Docket Number:	08-AFC-07C
Project Title:	GWF Tracy (Compliance)
TN #:	206446
Document Title:	Letter Regarding Supplement to Petition to Amend regarding Alternative Water Supplies
Description:	N/A
Filer:	Paul Kihm
Organization:	Latham & Watkins LLP
Submitter Role:	Applicant Representative
Submission Date:	10/28/2015 1:53:17 PM
Docketed Date:	10/28/2015

Re: Docket No. 08-AFC-07C
GWF Tracy Combined Cycle Power Plant
Petition to Amend Regarding Alternative Water Supplies

Exhibit A

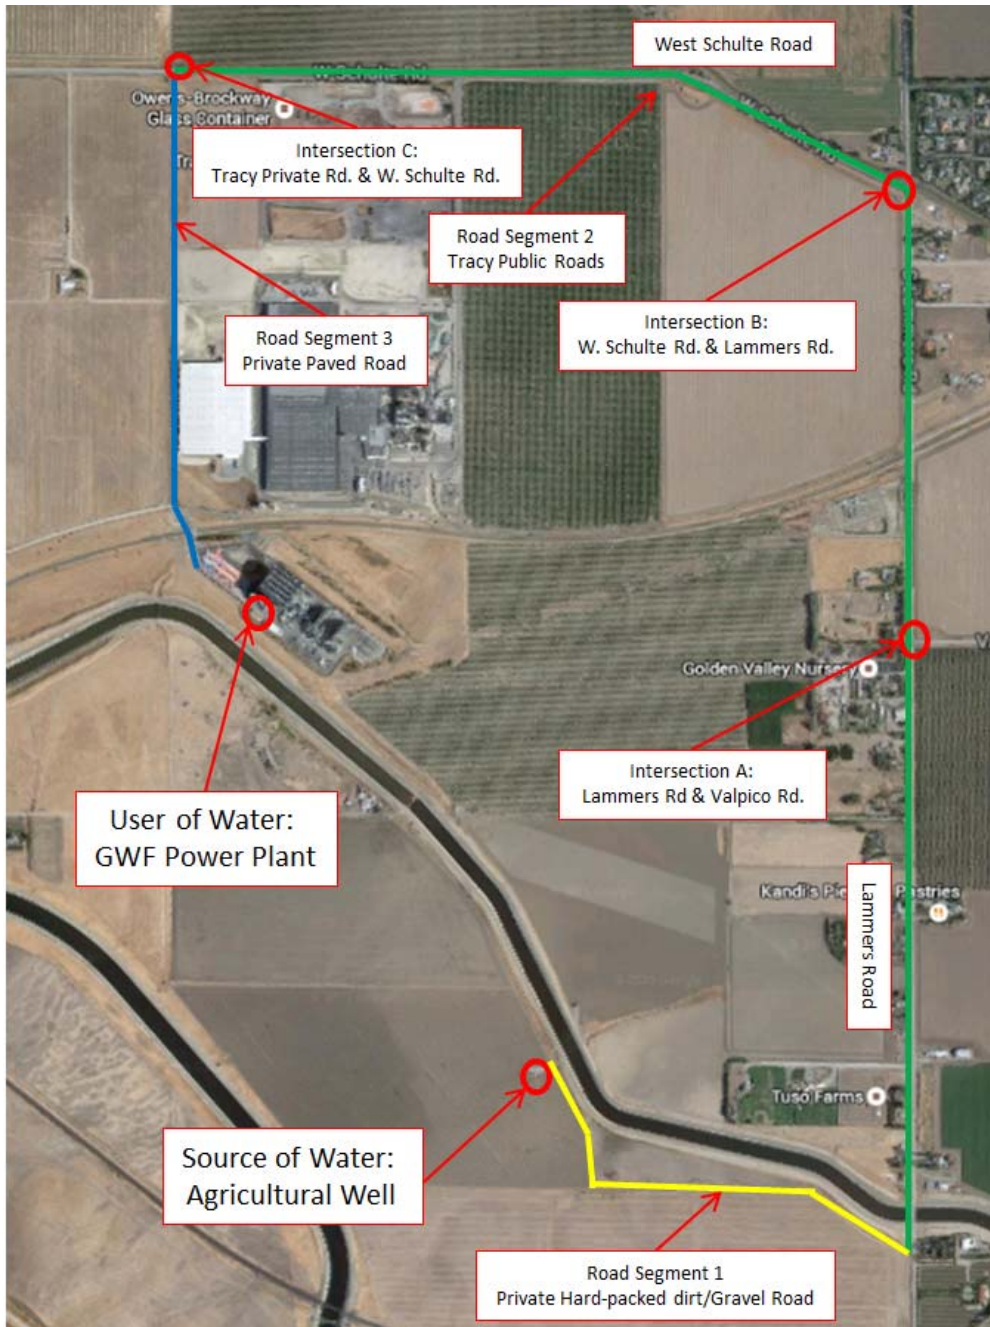
2. Please confirm that the road segments along the route from the Bogetti Water well site to GWF Tracy are capable of accommodating the additional traffic associated with the trucking proposal (maximum 10 round trips per day).

3. Please confirm that no additional signage is necessary at the intersections along the truck route in order to allow for safe transport of water.

5. Please evaluate the need for dust suppression along the unpaved portions of the truck route.

Response: Exhibit A to this letter breaks down the truck route into the following segments:

- Segment 1 (Yellow on Exhibit A)
- Segment 2 (Green on Exhibit A)
- Segment 3 (Blue on Exhibit A)

Segment 1 consists of a hard-packed/gravel roadway on the Bogetti property. This road is currently utilized for agricultural equipment, some of which is comparable in size and weight to the trucks that will be utilized to transport water. Given current usage of this segment and the limited number of additional trips, no impacts are expected to Segment 1. GWF's agreement with the Bogetti family obligates GWF to compensate the Bogetti family for any adverse impacts on their property as a result of use of the Bogetti Water, which would include any impacts to the roadway.

Segment 2 of the route consists of paved public roads within San Joaquin County. These roads are designed and built for, and regularly carry, trucks similar to those that will be utilized to transport water. Exhibit C to this letter is a Traffic Count Map available on the City of Tracy website at http://www.ci.tracy.ca.us/documents/Traffic_Count_Map.pdf. It illustrates that the affected public roads – Lammers and Schulte, have average daily traffic of 6,200 – 7,600 and 11,200 – 13,800 vehicles, respectively. The additional truck trips associated with this request are well within the design capacity of the roads and represent a de minimis increase in current traffic. GWF Tracy commits to repairing any damage caused to public roadways as a result of transport of water.

Segment 3 is the existing GWF Tracy entrance, which was designed and built for, and regularly carries, trucks similar to those that will be utilized to transport water. This segment is a paved asphalt private road on an easement held by GWF on privately held property. The road is maintained by GWF as part of the easement agreement.

Response: Exhibit A identifies by letter each of the intersections along the proposed truck route. The existing signage at each of these intersections is described below.

- Intersection A: Lammers Road and Valpico Road
- Intersection B: Lammers Road and West Schulte Road
- Intersection C: West Schulte Road and private road leading to GWF Tracy entrance road

Intersection A has a right of way on Lammers Road along the truck route going both directions, with a stop sign on the crossing street, Valpico Road.

Intersection B is a four-way stop and will be a left turn on the route of a truck leaving from the Bogetti Well and a right turn for trucks leaving from GWF Tracy to the Bogetti Well.

Intersection C is left turn, with right-of-way given to traffic coming from the opposing direction on the route leaving from the Bogetti Well to GWF Tracy. The return journey from GWF Tracy is a right turn, with a stop sign on the truck route with right-of-way yielded to oncoming traffic.

Given the existing intersection signage, and the limited number of additional truck trips that will be added to the intersections, no additional signage is required to safely transport water along the proposed truck route.

Response: Only Segment 1 of the truck route is unpaved. Given the limited number of trips associated with this proposal, dust generation is expected to be minimal and consistent with what currently occurs as a result of agricultural operations. Therefore, additional dust suppression is not necessary.
